SR Attribute Alignment

John Petrilla,
Avago Technologies
March 2010

Comments 31 & 32

TP1 Jitter, TDP, VECP & SRS Alignment

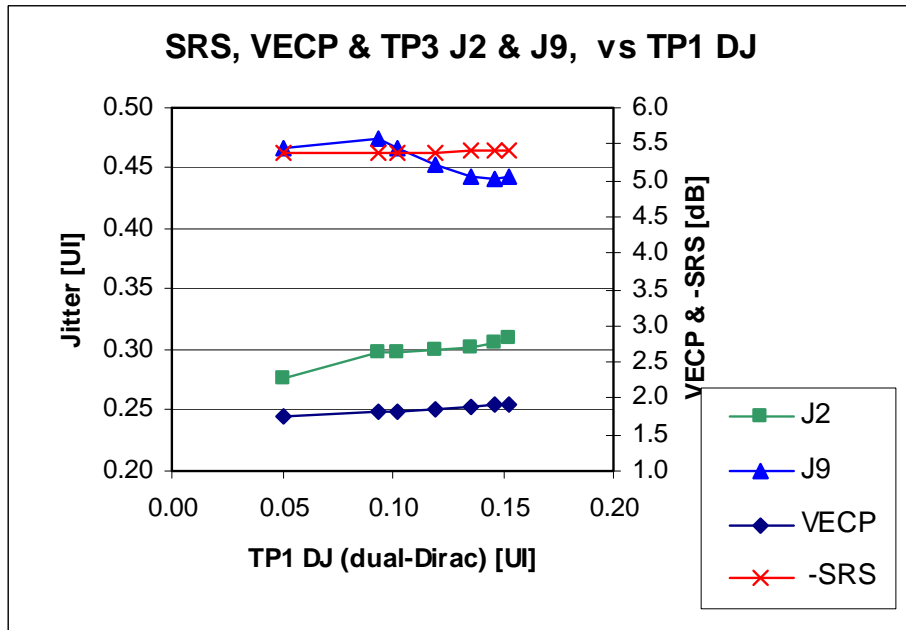
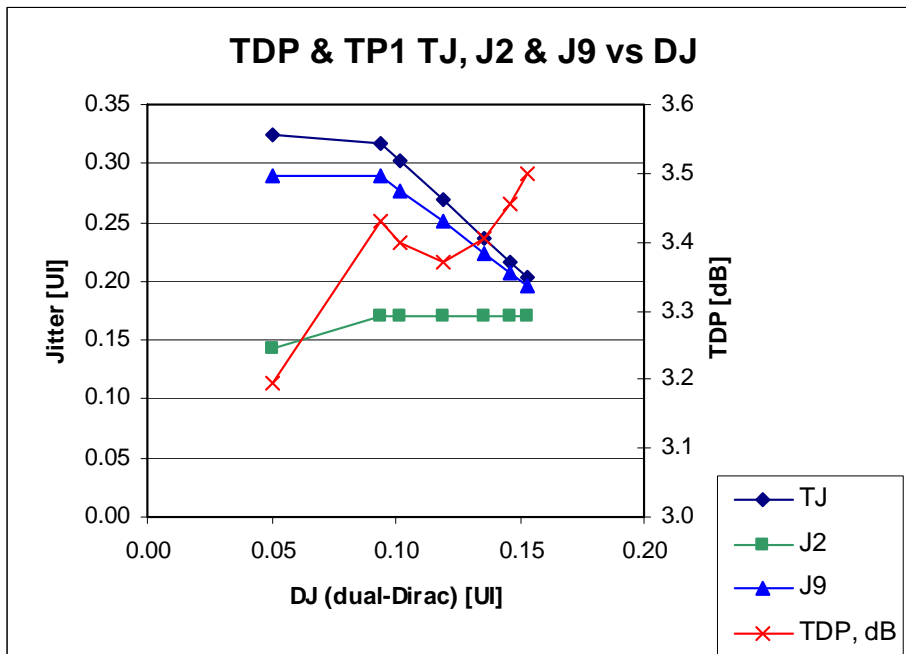
TDP and TP1 jitter are shown in the top chart while SRS, VECP and TP3 jitter are shown in the bottom chart for various combinations of TP1 RJ and dual-Dirac DJ. These combinations yielded either the TP1 J2 or the TP1 J9 max limit for the previously described worst case Tx. The combinations ranged from RJ = 0.050 UI & DJ(dD) = 0.153 UI to RJ = 0.274 UI & DJ(dD) = 0.050 UI.

For these combinations, TDP can be seen to reach the proposed max limit of 3.5 dB for the max TP1 dual-Dirac DJ case while at TP3, VECP, J2 & J9 are quite close to the specified test condition with SRS reaching the -5.4 dBm limit.

Min OMA at max TDP was changed in D3.1 from -3 dBm to -3.1 dBm. While not included in the optical specifications, this is the entry in the link model that determines the power budget and affects SRS and RJ calculations. The value should be returned to -3 dBm or the SRS limit should be adjusted.

In summary, the proposed TDP limit of 3.5 dB combined with a return to -3 dBm as the min OMA at max TDP value yields a well aligned combination of TP1 J2 & J9, TP2 TDP and TP3 SRS, VECP, J2 & J9.
